**Economic and Social Council**Distr.: General
24 November 2017

Economic Commission for Europe**Inland Transport Committee****World Forum for Harmonization of Vehicle Regulations****Working Party on Passive Safety****Sixty-second session**

UN Regulation No. 129 (Lateral collision)**Proposal for Supplement 7 to UN Regulation No. 129
(Enhanced Child Restraint Systems)****Submitted by the expert from France***

Figure 2
Arrangement for testing a rearward-facing device, not supported by the dashboard

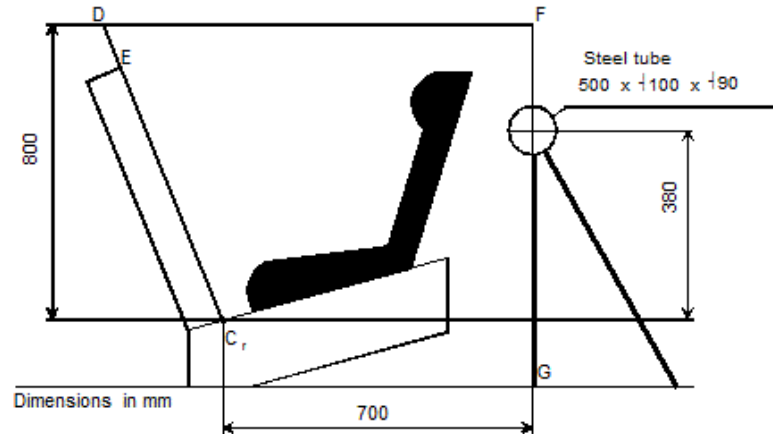
Paragraph 6.6.4.4.1.2.1, amend to read:

"6.6.4.4.1.2.1. Head excursion: no part of the head of the dummy shall pass beyond the planes FD, FG and DE, as shown in figure 2 below. This shall be judged up to 300 ms or the moment that the dummy has come to a definitive standstill whatever occurs first.

Except when testing using Q6 or Q3 dummy where the value in relation to the FD plane is 840 mm

In the case there is a contact of such a Child Restraint System with the 100 mm diameter bar and all injury assessment and dummy's head displacement criteria are met, there shall be one further dynamic test (front impact) with the heaviest dummy intended for the given range of size

indication and without the 100 mm diameter bar; the requirements for this test are that all criteria other than forward displacement shall be met.

Where a test is conducted in accordance with paragraph 6.6.4.1.6.2. above, only the second configuration without 100 mm diameter bar will be considered.

Figure 1
Procedure type 1

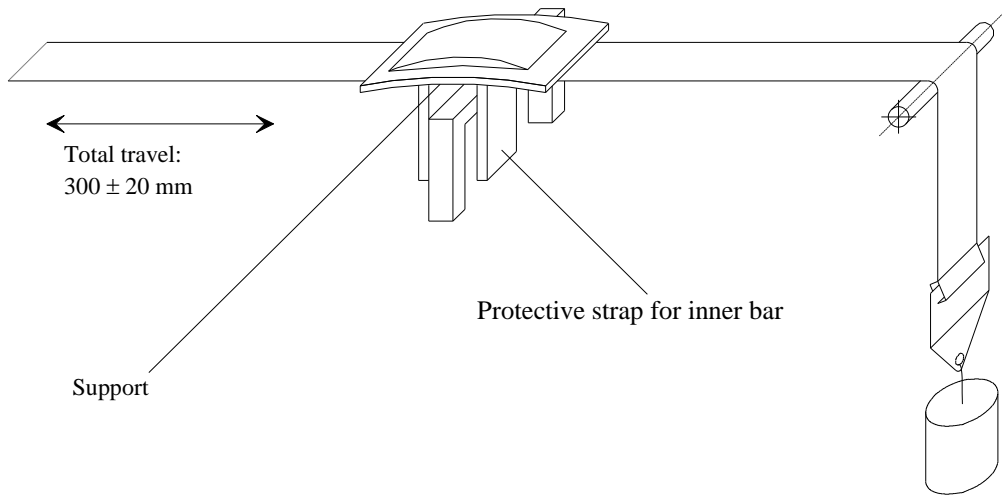
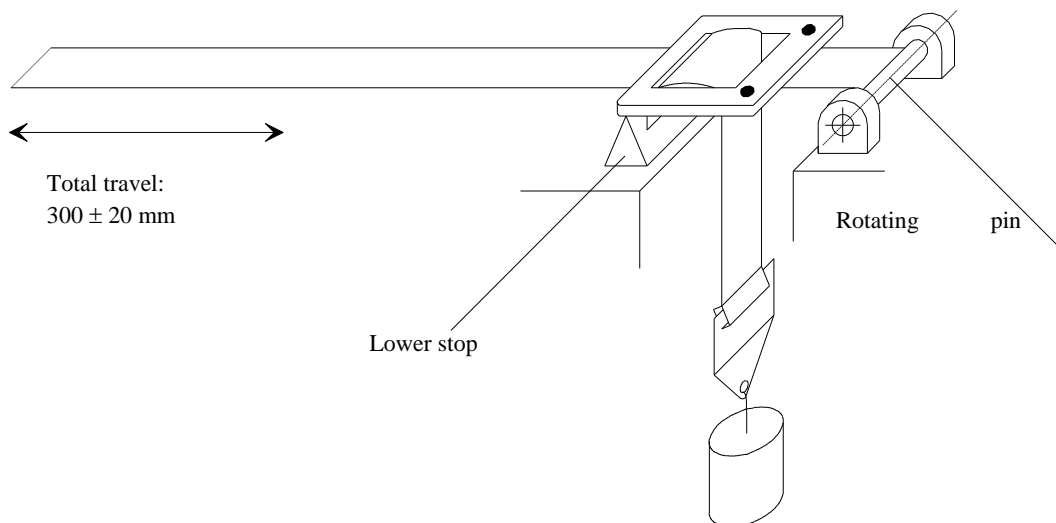
Annex 5, Figures 1 and 2, amend to read:

$F = 10 \pm 0.1 \text{ N}$, can be increased up to $F = 60 \pm 0.5 \text{ N}$ (see table 8 paragraph 7.2.5.2.6.2.)

Example b
 Examples of test arrangements corresponding to the type of adjusting device

$F = 10 \pm 0.1 \text{ N}$, can be increased up to $F = 60 \pm 0.5 \text{ N}$ (see table 8, paragraph 7.2.5.2.6.2.)

Figure 2
Procedure type 2
 Following two examples of test set up

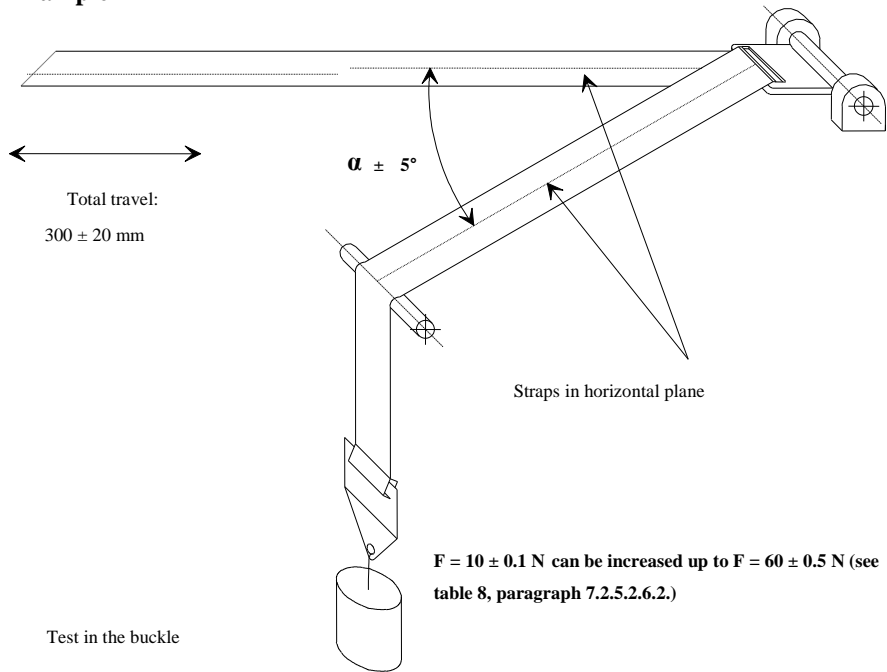
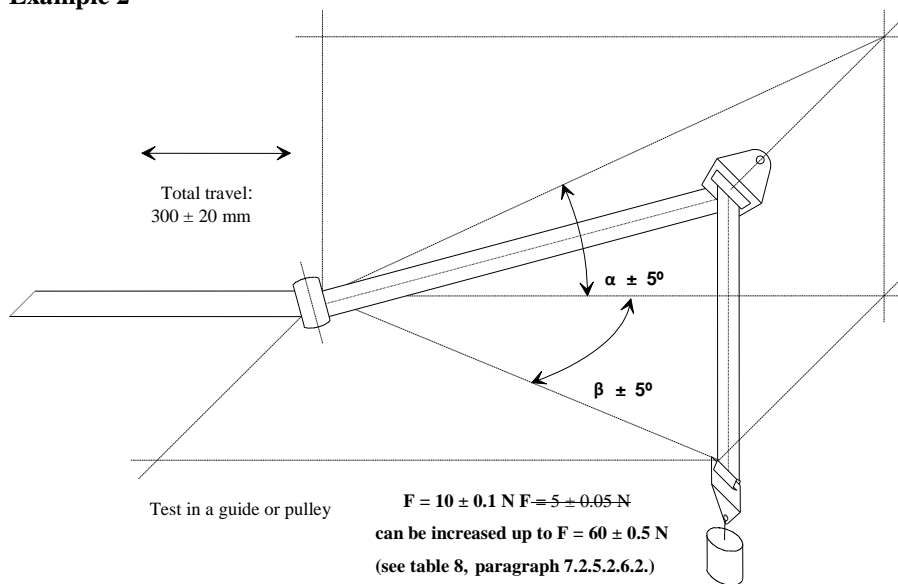
Example 1

Example 2

Where α and β reproduce the angles as in the real installation (in three dimensions)
 ..."
